OXFORDSHIRE COUNTY COUNCIL'S RESPONSE TO CONSULTATION ON THE FOLLOWING DEVELOPMENT PROPOSAL

Application no: P15/V1304/O & P15/S1880/O

Proposal: Mixed use redevelopment comprising up to 400 dwellings (C3), 110,000ms of Class B2/B8 units, 25,000m² of Class B1 units, 13,000m² Class A1 units (includes 1,500m² convenience food store), 150 bed Class C1 hotel and 500m² of Class A3/A4 pub/restaurant, including link road, related open space, landscaping and drainage infrastructure, together with reservation of land for link road and Science Bridge. Cross boundary application Vale of White Horse and South Oxfordshire.

Location: Land at former Didcot A Power Station Purchas Road Didcot

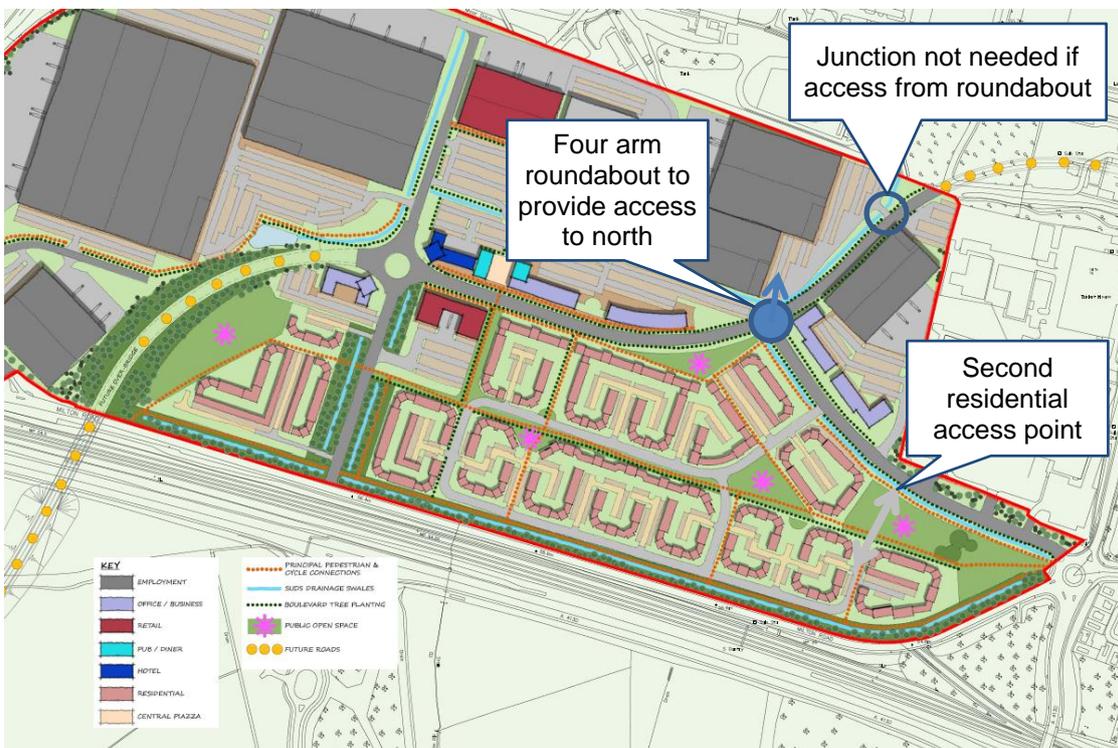
A third access is proposed from the west. It will comprise a 3 arm priority junction which will only provide local access to two commercial units (*Dwg: BMT/2113/100-06 Rev: P1*) via a cul-de-sac arrangement. The drawing showing the proposed junction arrangement indicates that it is a left out only junction. The geometry suggests that it is also right in (with a tight radii) although this is not clarified in *section 4.8* of the TA which sets out proposals for this junction.

This junction is close to a curvature in the road alignment which may impede forward visibility. Given that HGVs will take longer than other traffic to undertake an opposed right turn into the access road, the drawing should be annotated with

splays to ensure that vehicles on the mainline and those making turns to and from this junction have adequate visibility.

Within the site, the residential section of the site appears to be served from a single loop road which forms a priority junction with the primary access road (connecting the Power Station Roundabout to the Science Bridge Link Road). A second priority junction should be provided to enable an alternative vehicular access to the residential development (see *annotated plan below*) given that 400 units will be served.

Furthermore, the County Council considers that a roundabout would be a more appropriate arrangement for the junction formed between the Science Bridge Link Road and access road connecting to Power Station Roundabout (see *annotated plan below*). This arrangement would enable access to the employment site immediately to the north, through the provision of a four arm arrangement, without the need for the priority junction indicated to the north-east. As previously stated this site straddles the new link road known as Science Bridge. The new bridge over the railway line will tie into the A4130 south of the railway line and at the Purchas Rd roundabout to the east. Once opened this road will become the A4130 giving this site direct access to the strategic distributor road network. It is therefore vital that roads within the site are capable of delivering this strategic function without the requirement for retro-fitting.

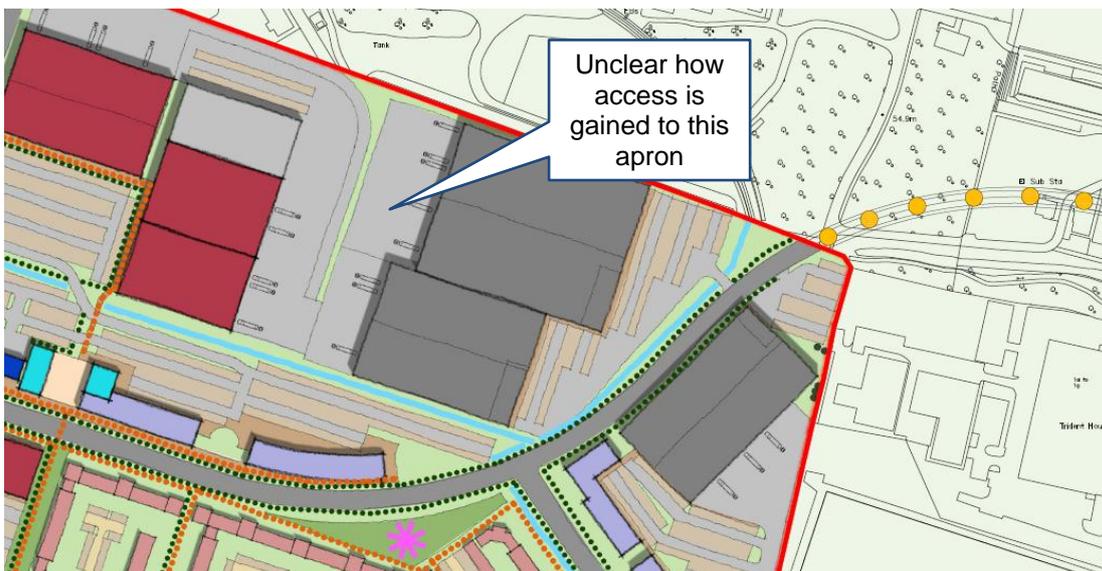
The 'bus based public transport' section of the TA has several inaccuracies and should be revisited as it does not present a reliable account of existing provision for the following reasons;

- Two route maps are included in *Figure 7* which do not correspond to the existing situation. It is considered that these maps are at least 5 years old and are out of date,
- Several bus routes identified do not stop in close proximity to the site and therefore it is felt that it is optimistic to suggest that they 'serve the site,'
- *Section 4.16* of the TA indicates that the site has been designed to enable public transport penetration with appropriate bus stops. Further details should be provided as to which bus routes it is proposed to divert into the site.
